## STAR ONLINE PUBLICATION

**Case Number:** S2523000015 Rev. A

**Symptom/Vehicle Issue:** Replacement Exterior Mirror Glass Connector Does Not Match For Blind Spot.

Fig 1.

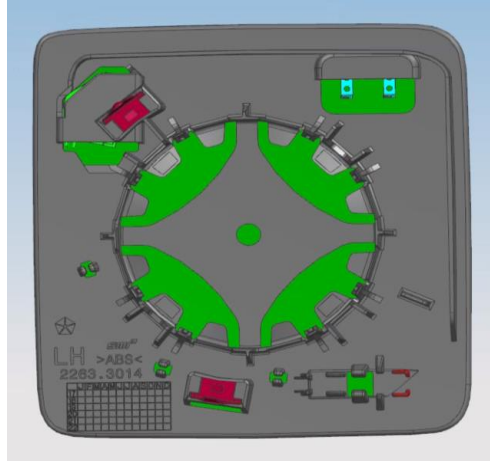
**Discussion:** During 2024 production there was an engineering change on exterior mirrors. The glass blind spot indicator changed. The “early mirror glass” design with the early blind spot is no longer available in MOPAR, however there is a “new mirror glass” design with the new blind spot monitor indicator for all the model years for production and service. This “new mirror glass” has a different connector for the blind spot indicator. An adapting jumper harness has been created to allow installation of the new mirror glass to the early mirror wiring with the new blind spot glass.

Requires Adapter Jumper Harness When Installing New Design Mirror Glass.

- If you have an old mirror and need replacement glass (Fig 1) – order a service glass + a JUMPER to allow a connection to the old mirror wiring. Jumper 68673054AA
- If you have a new mirror that needs replacement glass (Fig 2) – order a service glass only - no jumper needed.

Fig 2.

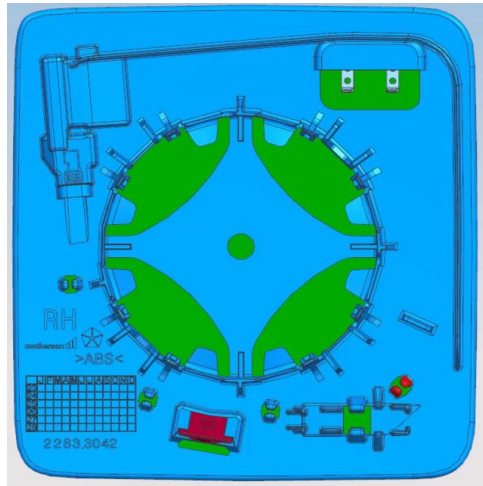
### New Mirror Glass Design Adapter Jumper Not Needed.
